INTER-DEPARTMENTAL REVIEW COMMITTEE REPORT

SITE PLAN APPROVAL - 650 S. SPRINGER DRIVE

OCTOBER 19, 2015

SPA 15-05

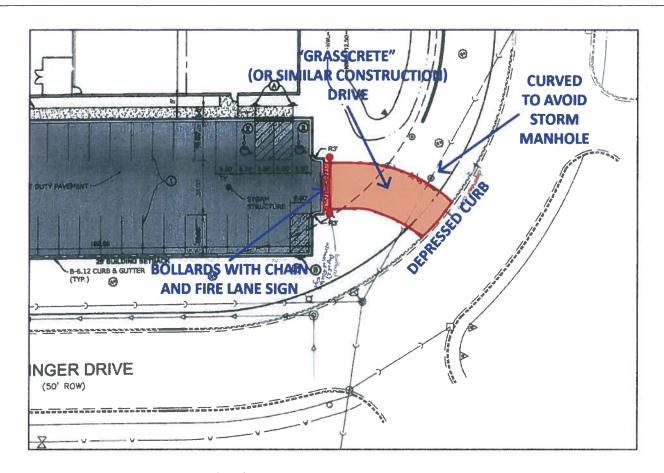
- As a condition of approval, an additional access point of "grasscrete*" (or similar construction method) with a depressed curb is to be provided for emergency access to the site in the location shown on page three.

Said "grasscrete" drive shall be designated a fire lane and must be maintained so that an emergency vehicle can access the site at any time, which includes keeping the fire lane free from snow;

- As a condition of approval, parking lot specifications and construction must be able to withstand the point load requirements of the largest Fire Department apparatus.
- * Grasscrete is a specific brand of concrete system with voids for grass to grow through but has load-bearing properties sufficient for emergency vehicles. For more information visit www.grasscrete.com.

- a. An additional "grasscrete" (or similar construction) access point be provided as directed by the Lombard Fire Department. Said access point shall have a depressed curb, identifying signage as a fire lane, and be maintained for access by emergency vehicles at all times.

- b. The parking lot specifications and construction must be able to withstand the point load requirements of the largest Lombard Fire Department apparatus;
